III. AMENDMENTS TO THE DRAWINGS

V. REMARKS

Enclosure(s): Amendment Transmittal
 Replacement Sheets of Drawing Figures 4 and 7
 Annotated Sheets of Drawing Figures 4 and 7

Fig. 4 *PRIOR ART*

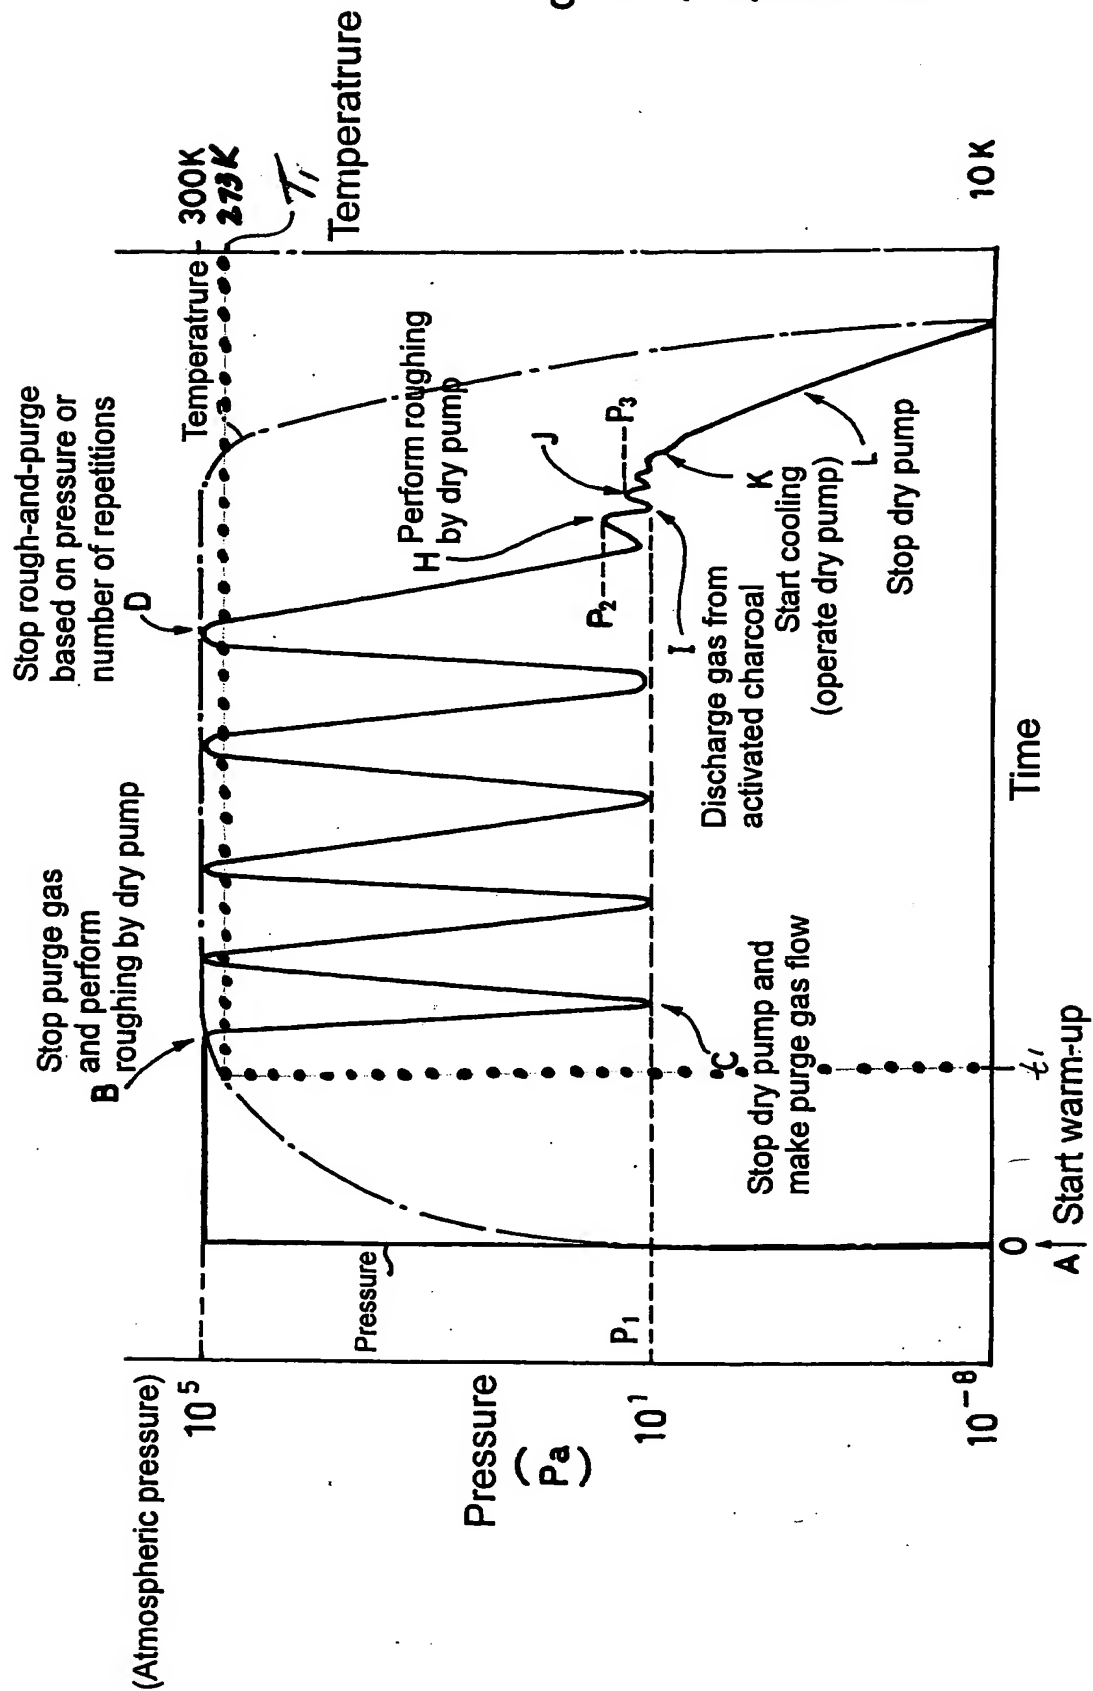
The Office Action recognizes the corrections to Figures 4 and 7. However, the Office Action finds these corrections to these figures are unacceptable because the dotted lines are

not labeled. The attached Replacement Sheets of Drawing Figures 4 and 7 now show the dotted lines being labeled.

Formal Replacement Drawing Figures 4 and 7 are filed herewith.
Replacement Drawing Figures 4 and 7 now show that the dotted lines are labeled.
